To: Rob Balland, PE
From: Pat O’Mahony, Associate Planner; 910-341-0189
CC: File;
Date: 10/30/2019
Re: Tru Colors Brewery TRC Rev. 1

Site Plan Comments:

GREENFIELD STREET

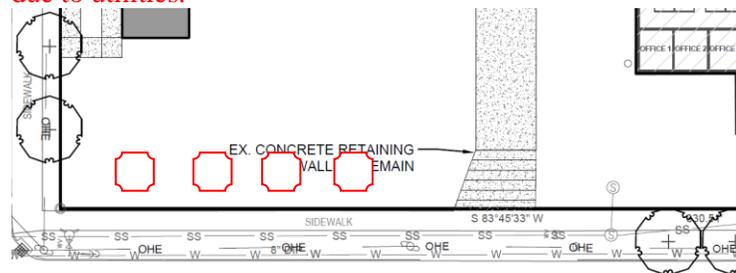
- **Comment: Surface parking must begin behind the front building façade closest to each property line. The parking area may need to be adjusted to ensure that all parking spaces do not encroach beyond a building façade. If unclear, please feel free to call me to discuss.**
